GUAM POWER AUTHORITY

AMENDMENT NO.: II

INVITATION TO BID NO.: GPA-047-25

T-7 TRANSFORMER REPLACEMENT (DESIGN-BUILD)

ATTACHMENT C.

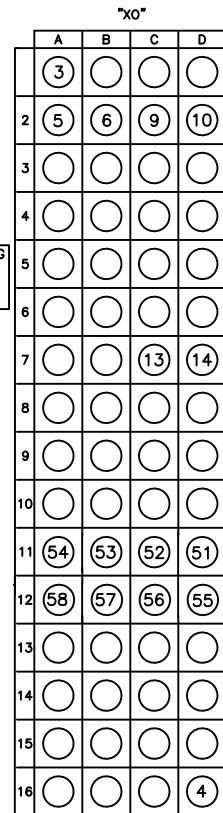
6. We are kindly requesting for a copy of the TP-7 breaker drawings to ensure that new CT's will fit to include the placement of terminal blocks.
- 6.1 Also request for any as built drawings for Piti Substation.

6. GPA does not have a copy of TP-7 breaker/switchgear cubicle record drawing since it was only turnover by the Navy to GPA. GPA only has the TP-7 schematic diagram. Refer to ***INCLUSION NO. 3*** above.
- 6.1 Refer to ***INCLUSION NO. 4*** above.
